## CITY OF PATASKALA PLANNING & ZONING COMMISSION

### STAFF REPORT

#### TCOD Application TCOD-19-002

### TCOD-19-002 Plan Review

**Williamson Insurance**  
**Landscape Plan (Amended)**  
**7856 Hazelton Etna Rd**  
**Pataskala, Oh**

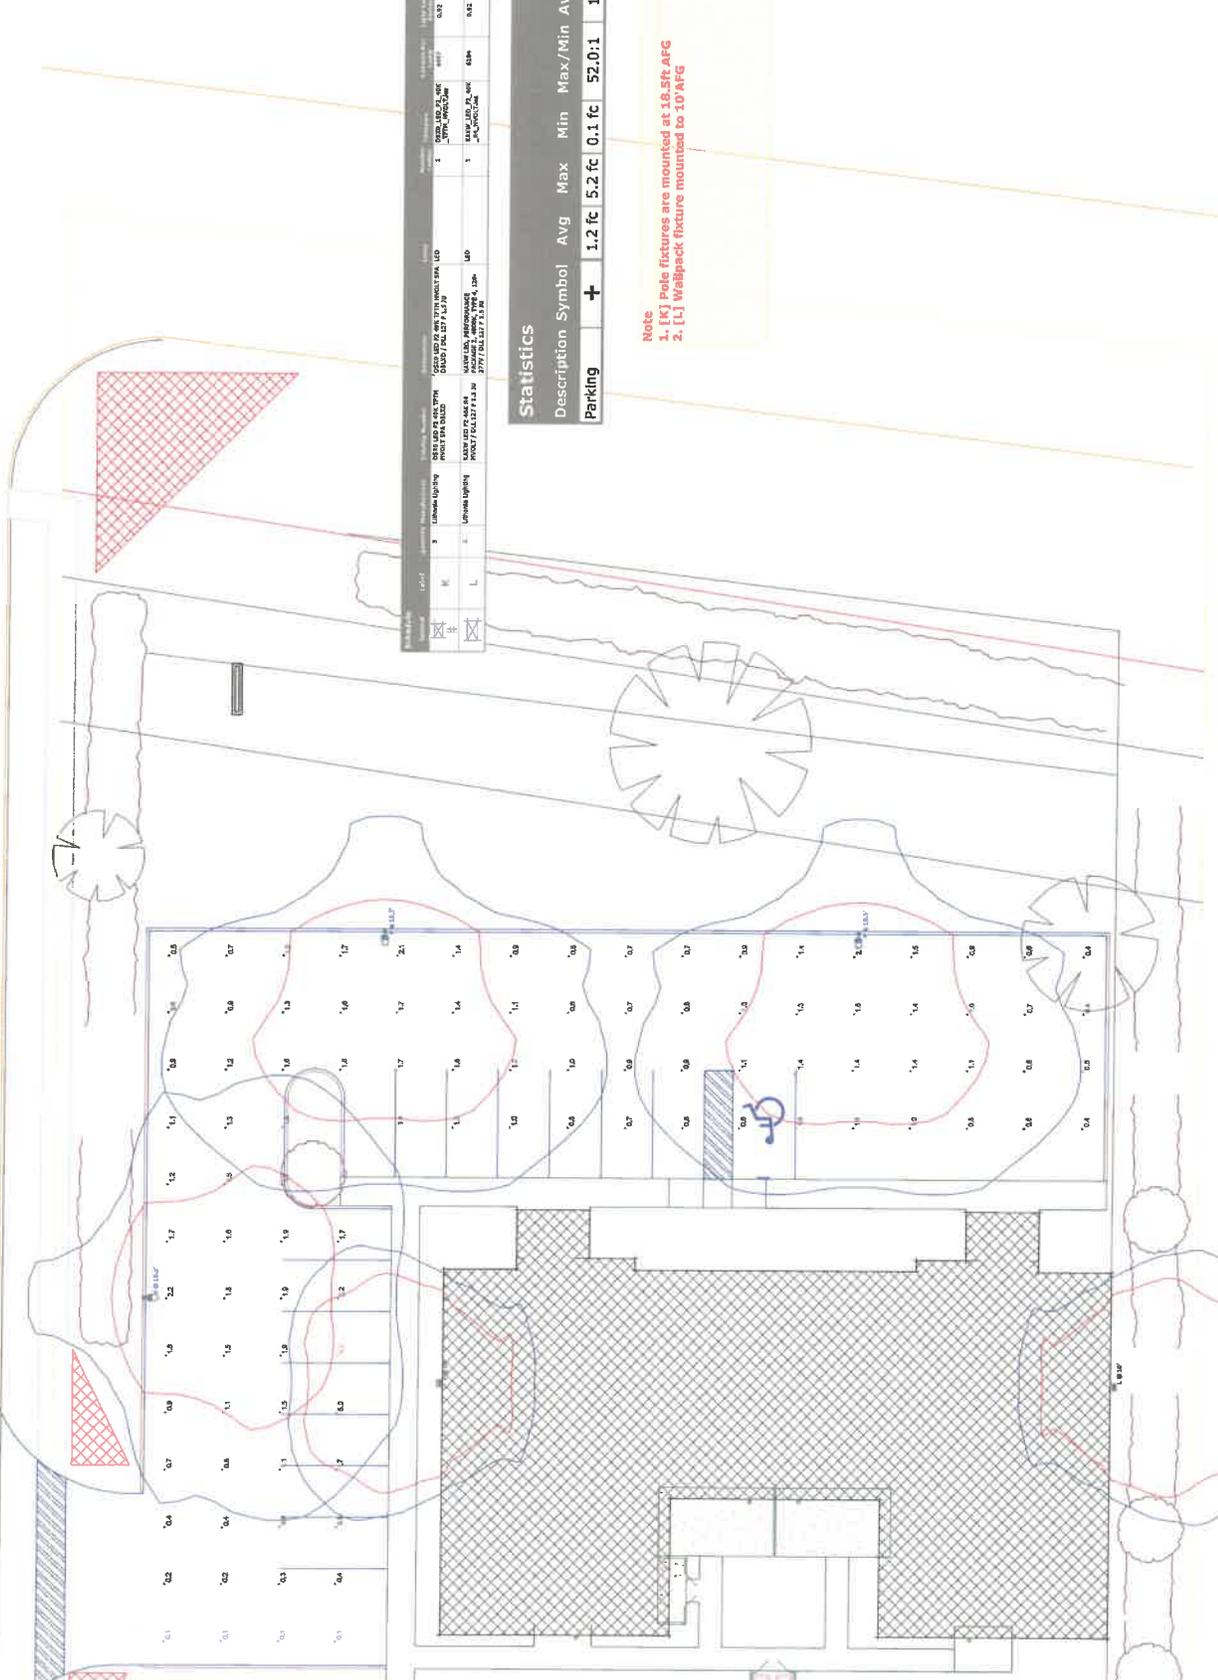
- a) The Applicant has proposed installing 5 trees on the north side of Sugar Mill Drive in lieu of having 1 tree per 30' (L2 requirement) on the east and north landscaping screening. Also stated, they would like to match this with 3 additional trees on the south side of the street if they were permitted to remove the large pine tree. Staff would like details on the locations of the 5 new trees, including distance from R.O.W., location of 3 trees on the south side the Applicant stated

- b) On the document supplied detailing the Landscaping Plan, the Applicant stated that he would like to install just "well-groomed grass" if PZC will allow. However, the he limitation text requires L2 landscaping unless a variance is requested.

- d) The 3' high shrub screen required by the L2 landscaping standards along the frontage of Hazelton-Etna Road (SR 310) will be within the 15' R.O.W. dedication. The L2 landscaping shall be relocated on to the applicant's property.

Monument Sign • Williamson Insurance • Pataskala • Ohio

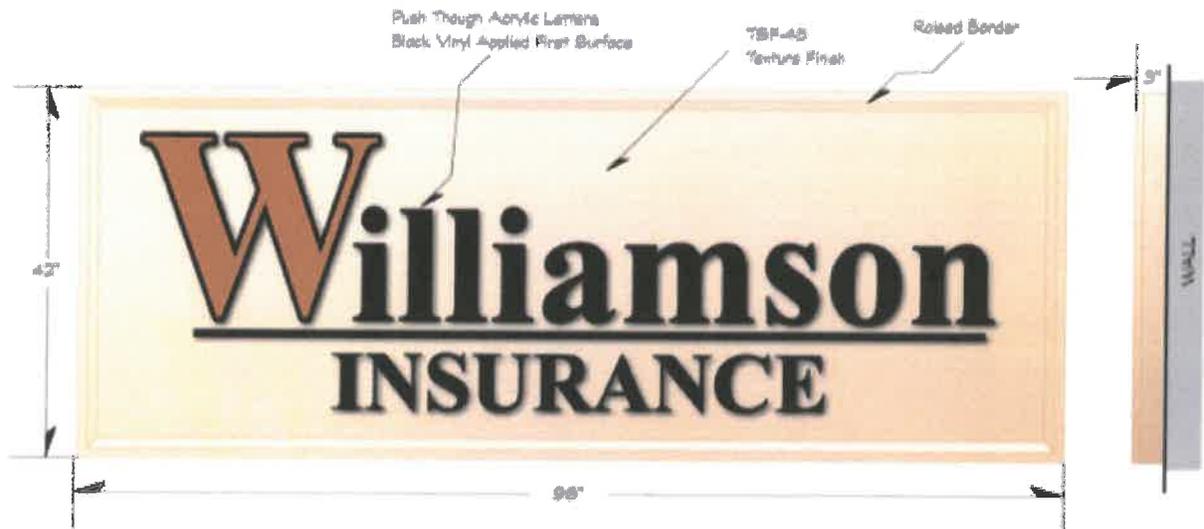
- 2) Signage:
- a) The proposed ground sign is 10' outside the proposed R.O.W., and a maximum of 10' in height, which is in compliance with Section 1295.09(b)(2)(C), however the square footage of the actual sign is not given. The document supplied is also very difficult to read.

Sheet Name *SITE PLAN*

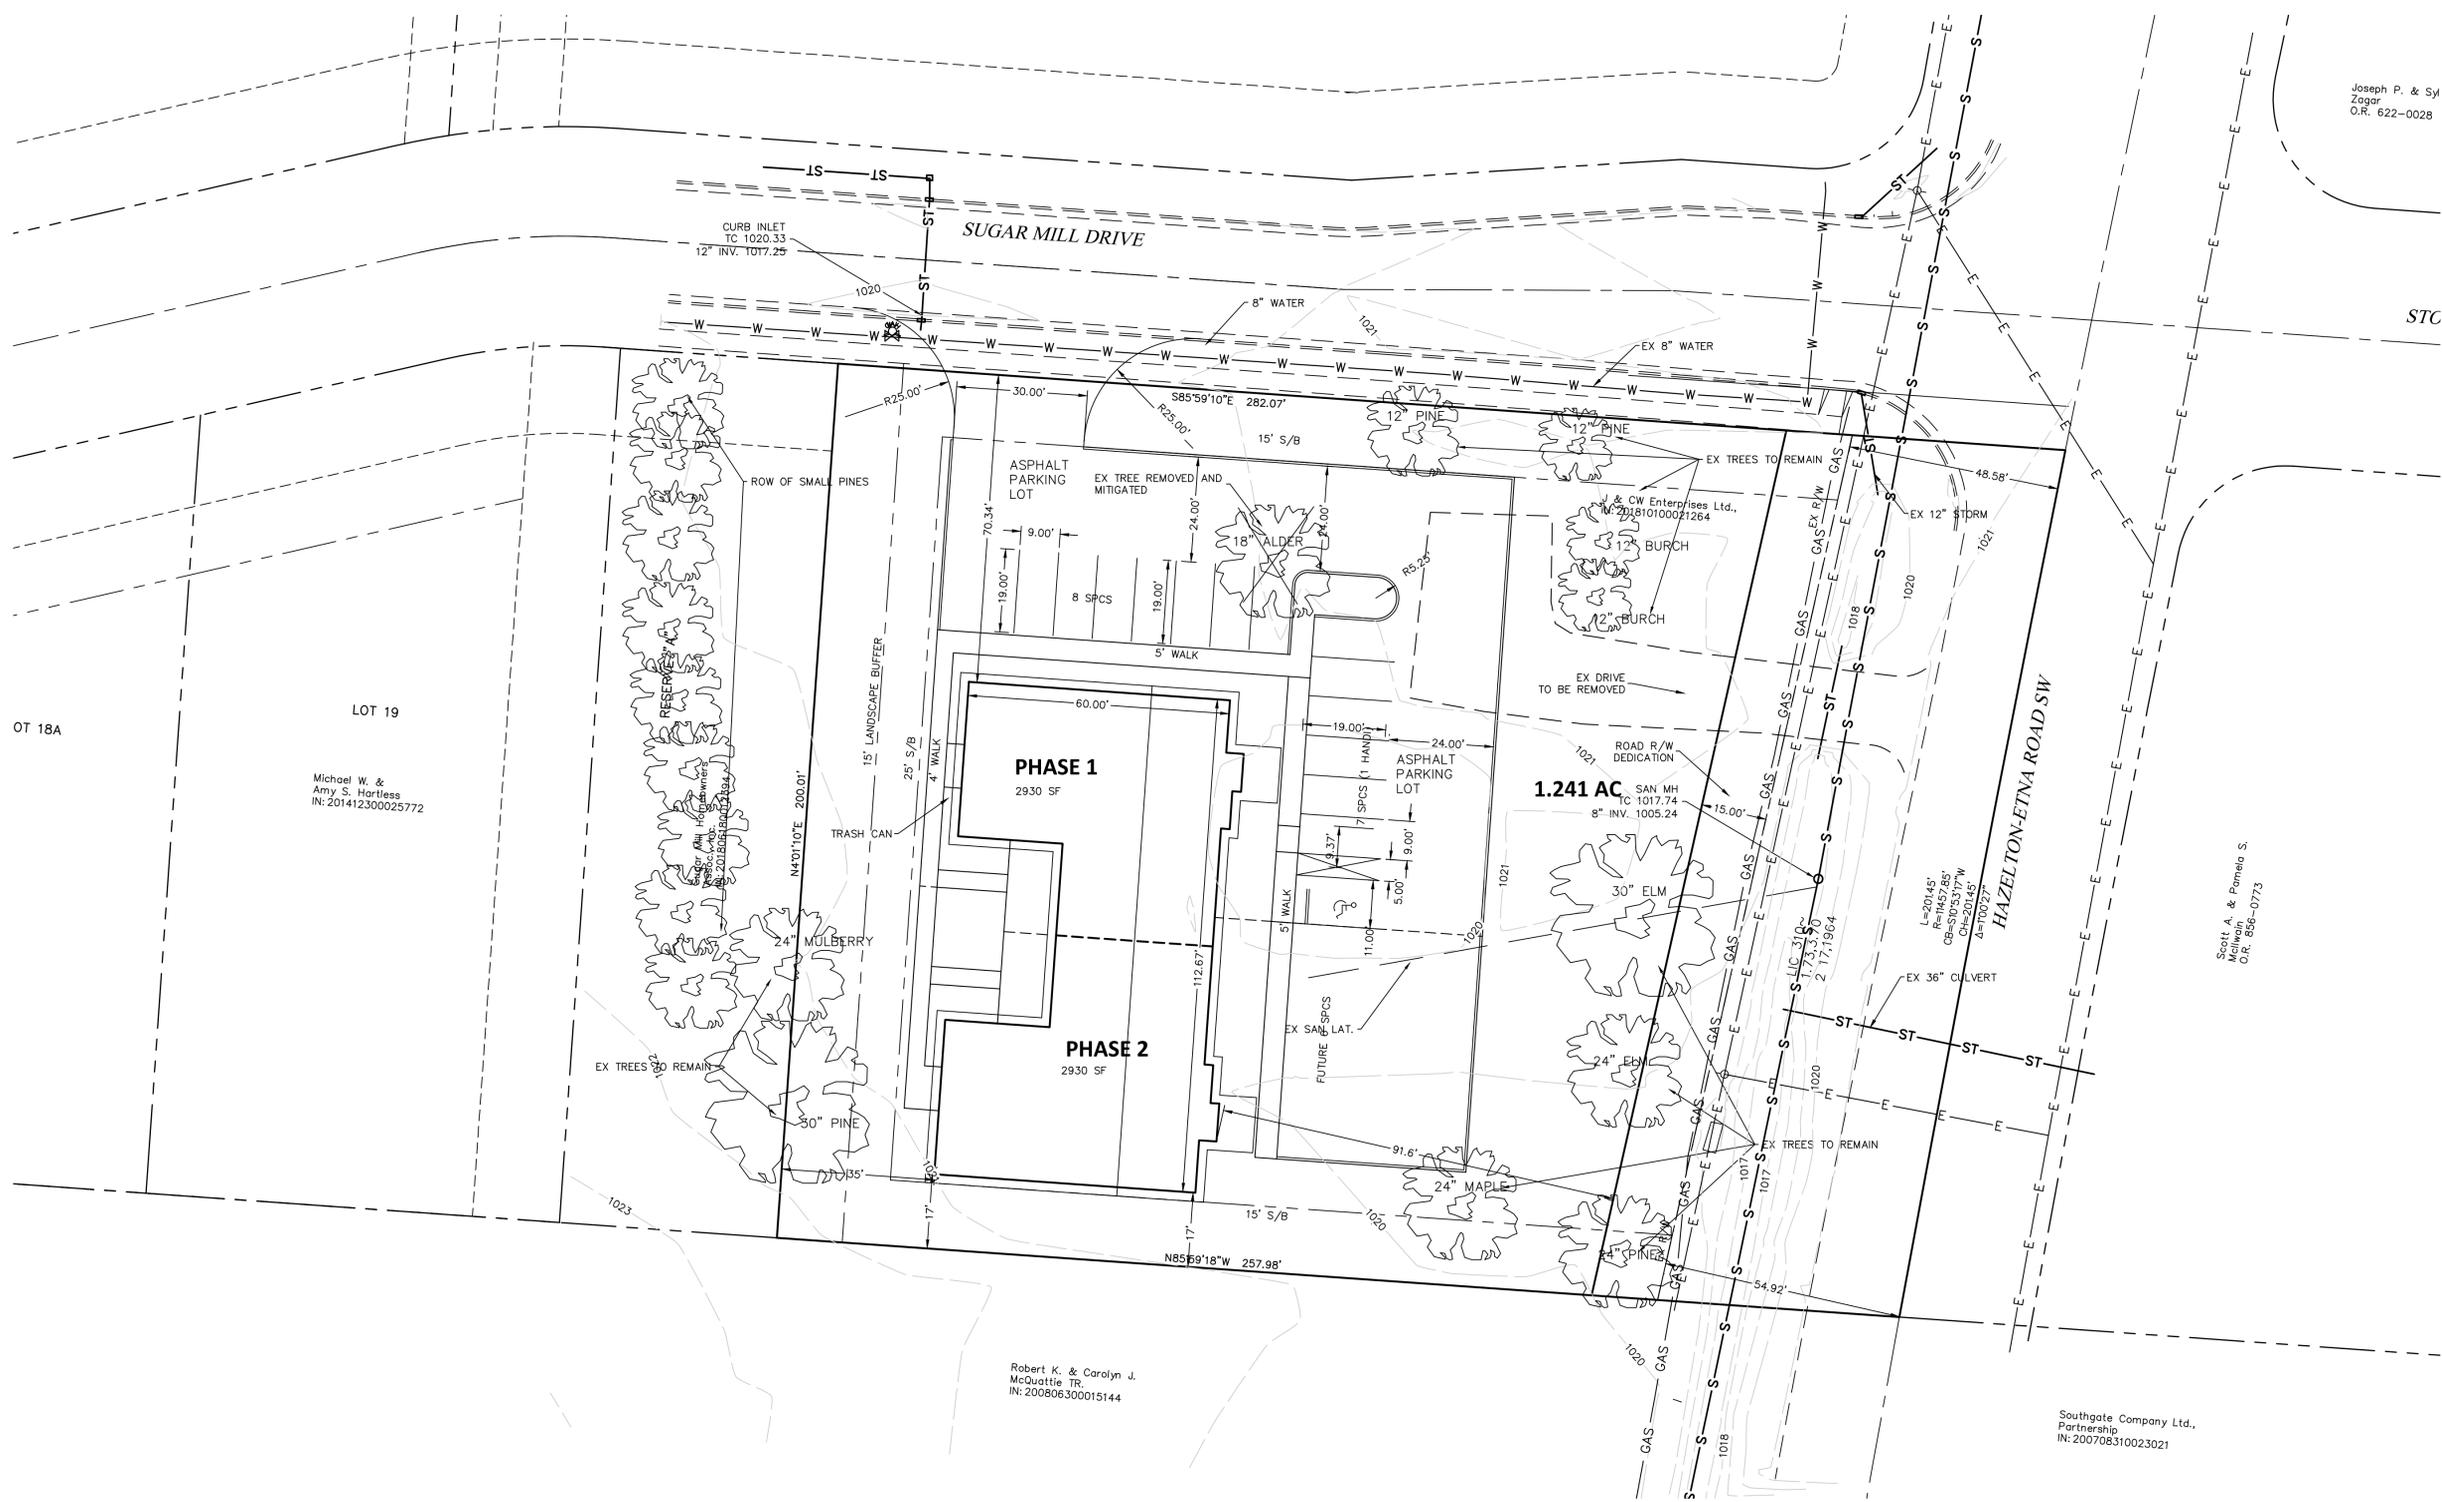
- 4) There are two separate Site Plans that were submitted. Some of the information given is different on each of the plans. Staff recommends creating one cohesive plan of set of plans that accurately depicts compliance with the Zoning Requirements. For example: one sheet showing the building setbacks, dimensions, etc., one sheet showing the landscaping and tree removal/replacement, one sheet showing utilities, one sheet showing the signage and lighting details, etc.

- i) The setback lines for the north and east side appear to be from the property line, not the R.O.W. line, please revise.
- c) 1259.05(E): New or upgraded utility lines shall be located underground. Please place a note on the site plan stating, "All utilities to be located underground".

**SITE PLAN**  
SHEET: **L-1.1**

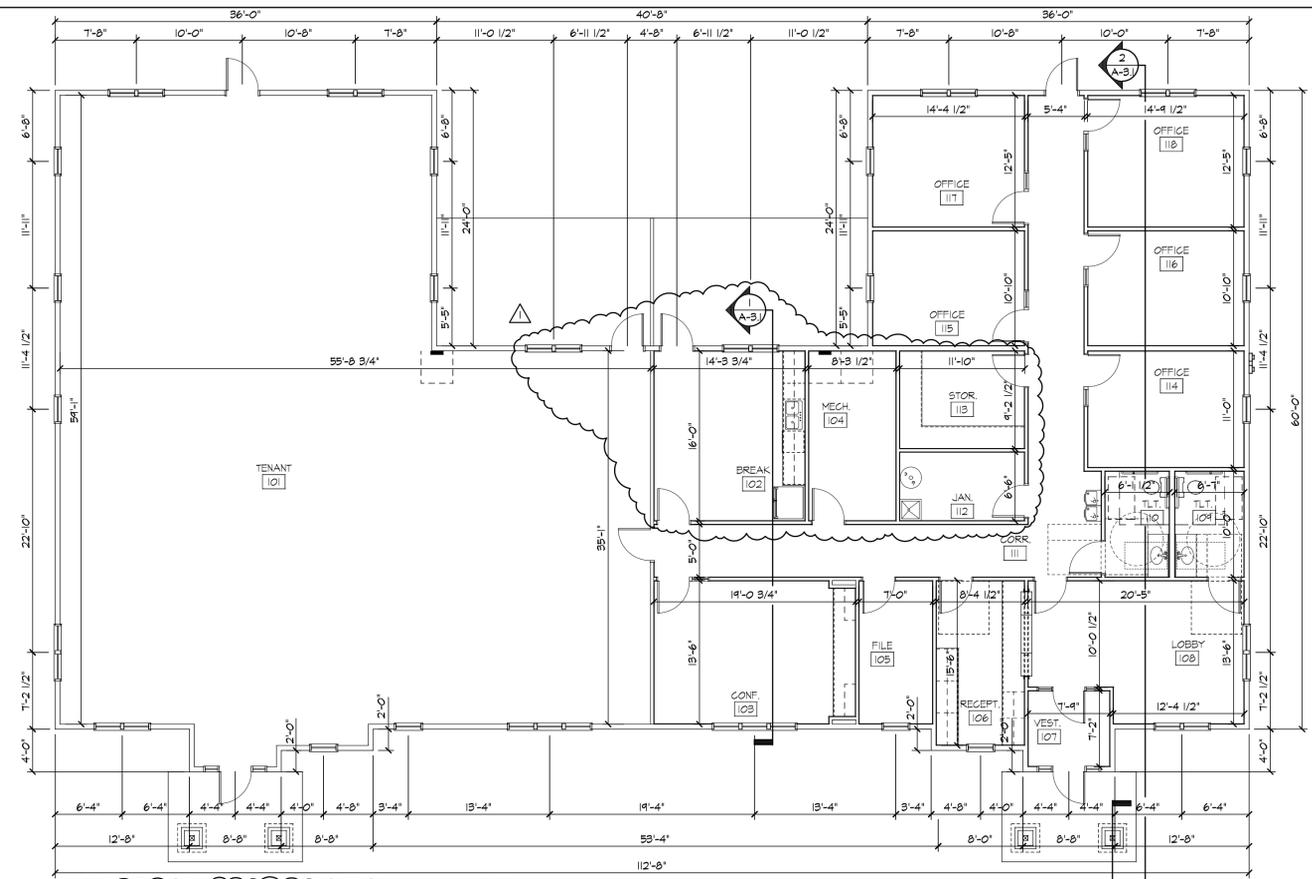
- 2) The proposed 3' hedge screen on the frontage of SR 310 will be within the new R.O.W. dedication. This must be moved back outside the R.O.W.
- 3) Will the trash enclosure and trash cans be sufficient for any use that may occupy Phase 2? Also, the two different Site Plans call for different locations of the trash enclosure. On Sheet L-1.1, it is shown in the middle of the rear courtyard. On Sheet 3, and Sheet A-1.2 it is shown to be located directly adjacent to Phase 1. Will Phase 2 have its own trash enclosure? If so, it must be shown.

- i) Please provide a measurement of this distance on the site plan to ensure compliance.
